**4 Amendment Requests:**  
**Corner Lake Gardens Preliminary  
Subdivision Plan (PSP)**

Case #PSP-22-12-362

August 8, 2023 BCC Meeting

Figure 2 (Current PSP)

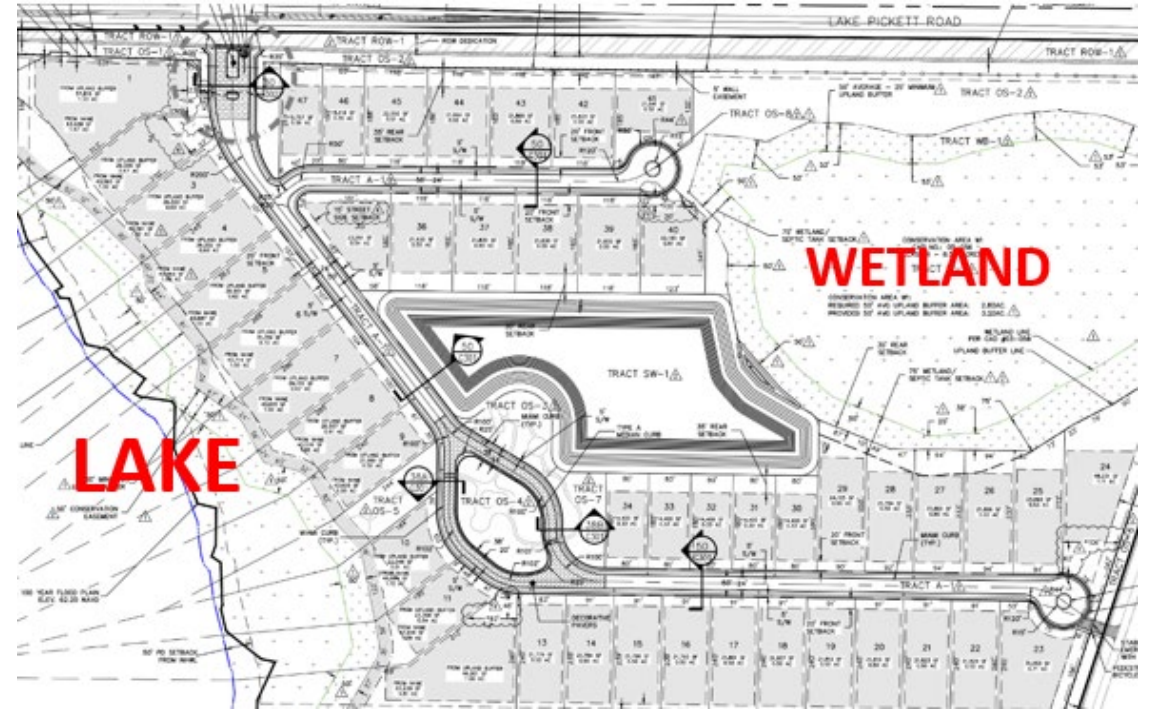
- Of the **47 lots** in this rural settlement PSP, **only 3 lots** are **1 acre lots** (Lot #'s 1, 12, and 24).
  - The 12 lake front lots have nearly half of the land buried in the lake.
  - **The other 44 lots** range from .33 acre to .72 acre with most lots being .5 acre.
    - The only rural settlement that was to have .5 acre lots in a conventional layout was Zellwood.
      - This was to at the threat of annexation - and that effort required modifying the Comp Plan.
  - Clustering is permissible in rural settlements in an effort to protect open space and/or environmentally sensitive lands - **this PSP does not represent a cluster subdivision.**

- It is NOT a Clustering Subdivision Layout
- It is a Conventional Subdivision Layout

1. **The PSP shall be amended to meet the criteria of a clustered subdivision, which is permitted in rural settlements. After which, the .3 and larger lot sizes work within established staff policy.**
  - 1a. **Or,** expand lot sizes to meet Conventional Subdivision requirements for Rural Settlement per staff policy
  - 1b. **Or,** do as Zellwood did - modify Comp Plan to allow for this PSP's special request
2. **Ensure subdivision will preserve the rural character in the area - CLUP OBJ FLU6.1 is**  
*"...intended to preserve rural character in the rural service area."*
  - 2a. **The maximum home height permitted will be 2 stories**  
(preserve rural character and keep consistency (3 stories violates Rural Settlement comp plan))
  - 2b. **Subdivision wall is in character with rural settlement**
